MODEL:	TYPE:	SECTION/GROUP:	DATE:
D Coaches	Field Change Program	08- Engine	July 9, 2018

Ref. MCI NHTSA Recall No.: 18V-309

Ref. MCI Transport Canada Recall No.: 2018-256

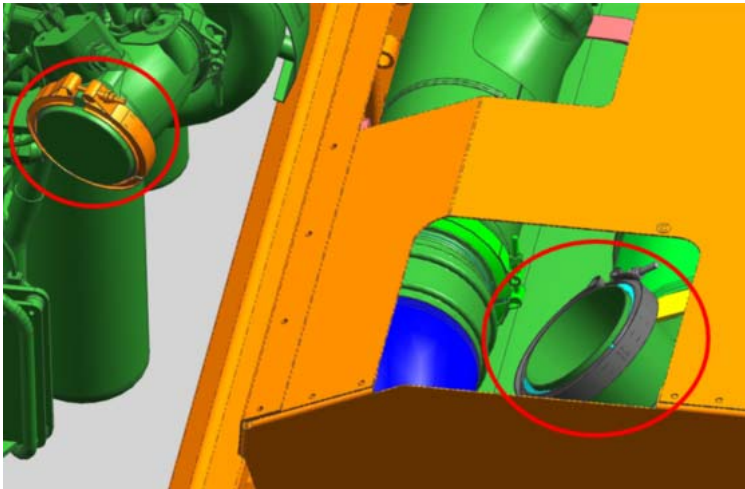
Remove the exhaust blanket from the existing exhaust pipe and install it on the new exhaust pipe.

Secure the blanket on the new pipe using the insulation blanket hook and spring mechanisms. Ensure that there are no gaps or holes along the edge of the blanket seams. No hook element is to penetrate or be inside the surface.
